UNITED STATES PATENT AND TRADEMARK OFFICE

Office Action Summary

This is the first Office Action for application number 10/565,178 Anchor Device for Supporting a Post, filed on 3/28/06. Claims 1-18 are pending.

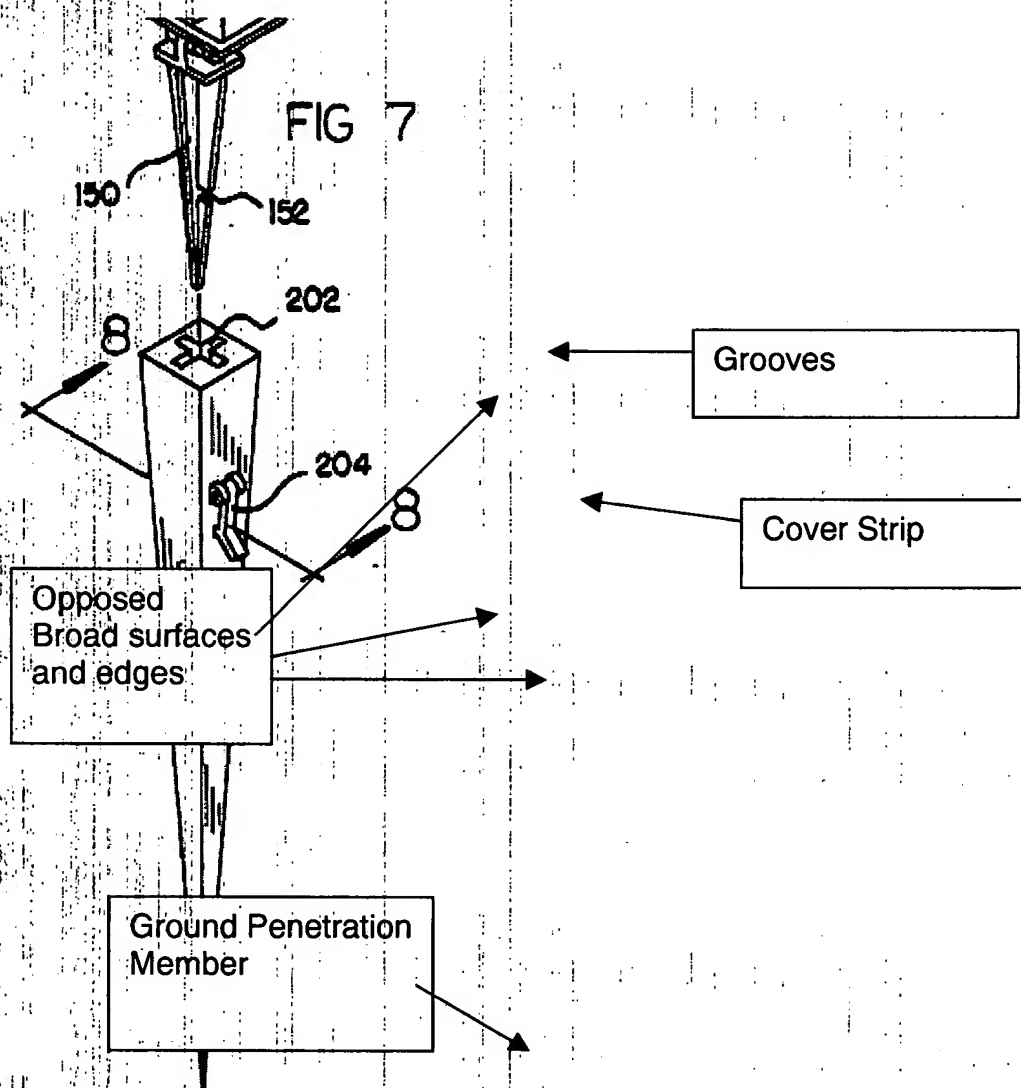
The patent to Holliman discloses a ground anchor for supporting a flexible post of plate like configuration having a pair of opposed broad surfaces (See Below) and a pair of edges, in the ground the ground anchor having a body (200) and one or more ground penetration members (See Below) and having a single internal socket (202) for receiving the guide post in use, the at least one internal socket having a cross-sectional shape being of corresponding shape to the flexible post (150) and having corresponding

grooves to match with corresponding edges of the flexible post wherein there is provided retaining means (204) having a latch projection (204a) extending into the internal socket and a latch aperture (See Figure 8) in the body for engagement with the latch projection for retaining the guide post within the at least one internal socket in use wherein the retaining means is located adjacent the at least one internal socket for effecting release of the guide post from the at least one internal socket when required wherein either of the latch projection is contactable by a tool (204b) to effect release of the retaining means to facilitate removal of the post from the ground anchor and wherein there is provided a cover strip (See Below) having the latch projection (204a) engageable with the body and the cover strip is contactable by the tool and a post (150) retained within the at least one internal socket with the retaining means including a latch projection (152) formed on one of the ground anchor wherein either of the latch projection or the latch aperture are engageable or have an adjacent surface of the body contactable by a tool to effect release of the retaining means to facilitate removal of the post from the ground anchor and
